UNITED STATES PATENT AND TRADEMARK OFFICE

Office Action Summary	Application No. 10/811,667	Applicant(s) LITTLE ET AL.	
	Examiner Sarah Suereth	Art Unit 3749

DETAILED ACTION

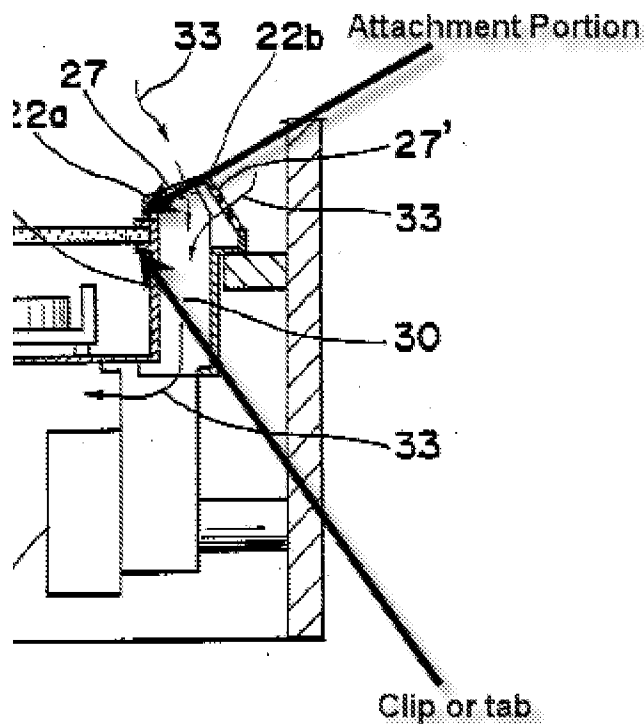
Arai discloses a stove vent trim element (22) shown mounted to the rear surface of a cooktop (20). The vent trim includes an upper horizontal flange regarded as the claimed attachment portion, and a lower horizontal flange regarded as the claimed clips or tabular portion along the bottom of the cooktop surface. A portion of Arai Figure 2 has been relabeled below for clarity.

As discussed above, Levi discloses the claimed invention with the exception of a mounting clip overlapping a bottom surface of the cooktop.

It would have been obvious to one of ordinary skill in the art at the time the invention was made to modify the Levi apparatus to include the vent trim structure of Arai in order to further elevate the vent cover from the cooktop structure. Levi shows

the vent cover essentially parallel, while Arai teaches a sloped surface. The sloped surface of Arai obviously aids in preventing liquids from accidentally entering the burner ventilation structure.
